APPENDIX D
REGIONAL MODEL AND CONFIDENCE BUILDING
(RESPONSE TO USFIC 5.02, USFIC 5.12, AND USFIC 5.11 AIN-1)

This appendix provides a response for Key Technical Issue (KTI) agreements Unsaturated and Saturated Flow Under Isothermal Conditions (USFIC) 5.02, USFIC 5.12, and an additional information needed (AIN) request on USFIC 5.11. These KTI agreements relate to providing more information about the use of the regional-scale model in the site-scale saturated zone flow model (SSFM) and the Solitario Canyon alternative conceptual model.

USFIC 5.11 AIN-1

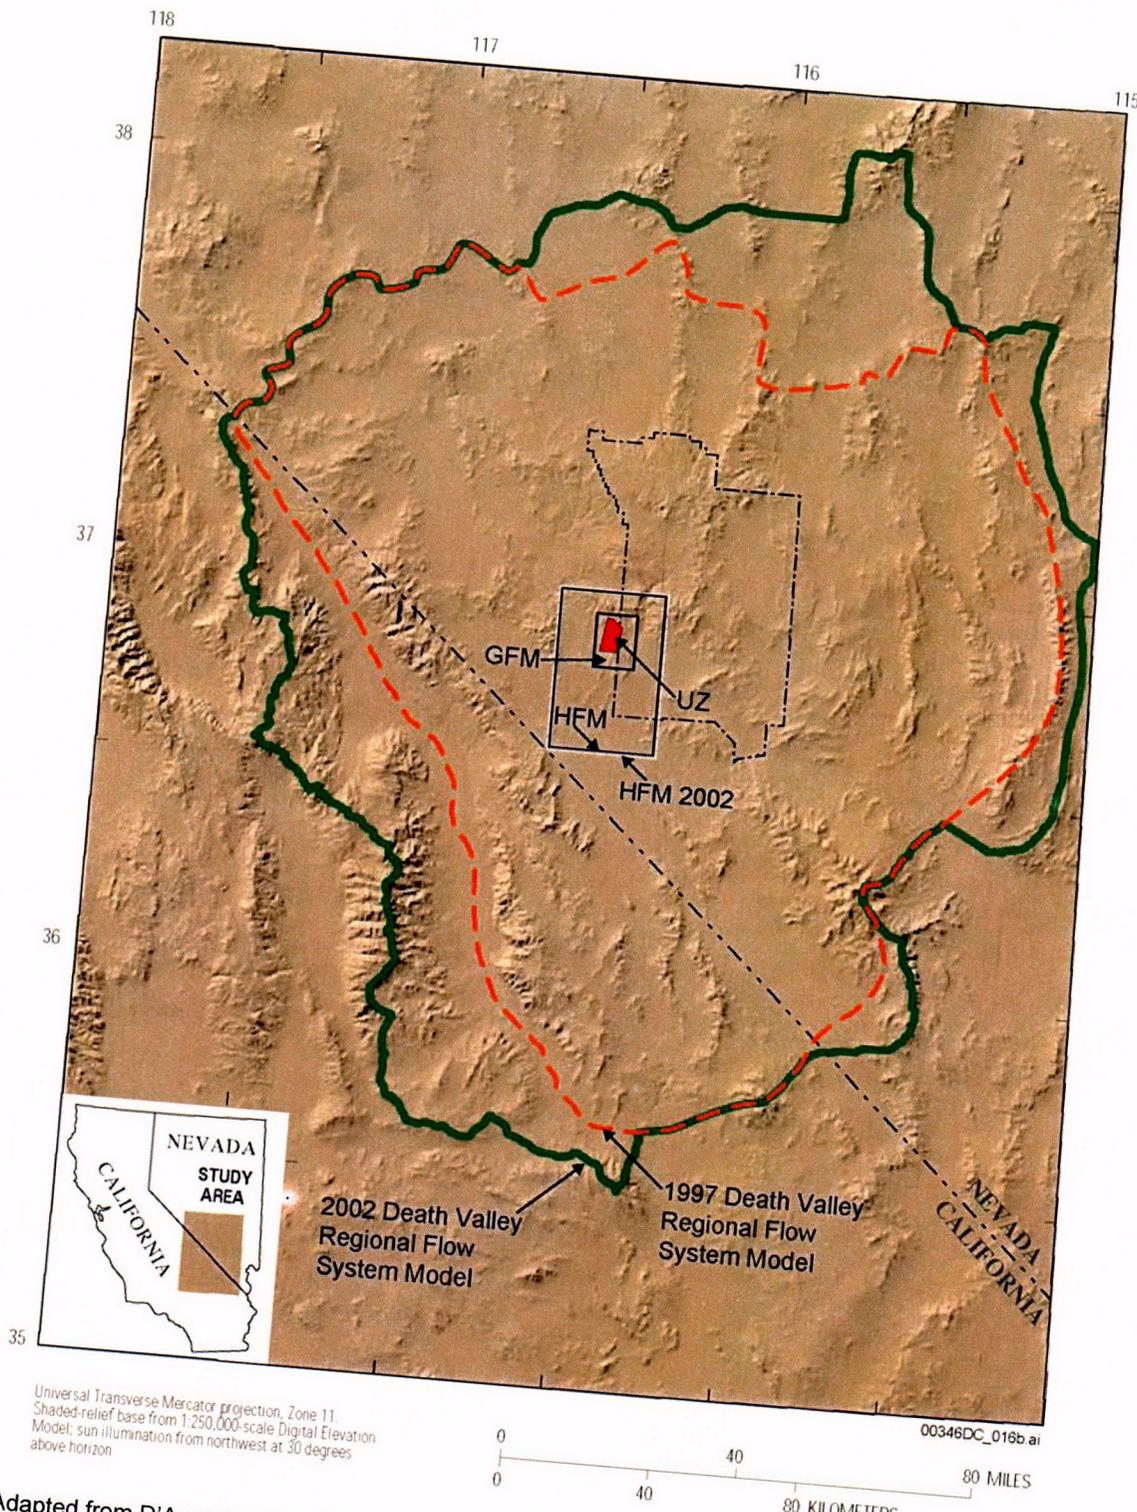
1. To examine flow and potential radionuclide transport in the deeper aquifer system, a vertical cross-sectional figure showing the flowpaths is needed. As an example, the left diagram of Figure 8 in the Calibration of the Site-Scale Saturated Zone Flow Model AMR (CRWMS M&O 2000) shows such a cross-sectional view. Two such particle tracking figures showing distance vs. depth are needed: one for the calibrated model and another for the shallow Solitario Canyon Fault alternative model.

2. To test the hypothesis that potential contaminant releases on the west side of a shallow Solitario Canyon Fault might enter the lower carbonate aquifer, DOE should provide an analysis of flow paths from the west side of a shallow Solitario Canyon Fault. Alternatively, DOE could provide an explanation of repository design and site characteristics that would preclude contaminant releases to the west side of the Solitario Canyon Fault.

Response to USFIC 5.11 AIN-1 (Comment #1 and Comment #2)—To investigate the importance of the depth of the Solitario Canyon fault, an alternative conceptualization was simulated in which the fault only extended from the water table to the top of the carbonate aquifer (BSC 2003a; see also Section D.4.3). This alternative, referred to as the shallow fault alternative model, was identical to the SSFM in all respects except for properties of the Solitario Canyon fault. The shallow fault alternative model only changed the computation grid where necessary to implement the alternate formulation of the fault. The shallow fault alternative model was calibrated in a manner identical to the SSFM. Areal and vertical slice flow paths for the different model scenarios are illustrated in Figures D-15 through D-18. For each of these figures, the left side shows the flow paths in vertical cross-section, and the right side shows the corresponding flow paths in map view.

Simulations using the two conceptualizations of the Solitario Canyon fault (original and alternate) produced essentially the same results, and the simulated water levels, hydraulic gradients, and transport pathways were little affected by the alternative conceptualization. Both conceptualizations yielded the same flow paths from the water table under the repository to the accessible environment, and transport times were not affected by the depth of the fault. The influence of reducing the depth of the Solitario Canyon fault on total system performance is expected to be minor. This alternative conceptualization resulted in no major changes to the flow system and has no consequences for radionuclide transport.

Based on current designs, the repository will be located east of the Solitario Canyon fault. A study of potential radionuclide flow paths in the unsaturated zone indicated that a negligible number of particles would reach the water table west of Solitario Canyon fault within the 10,000-year regulatory period. Therefore, the alternative conceptualizations of the Solitario Canyon fault have little effect on transport in the saturated zone.
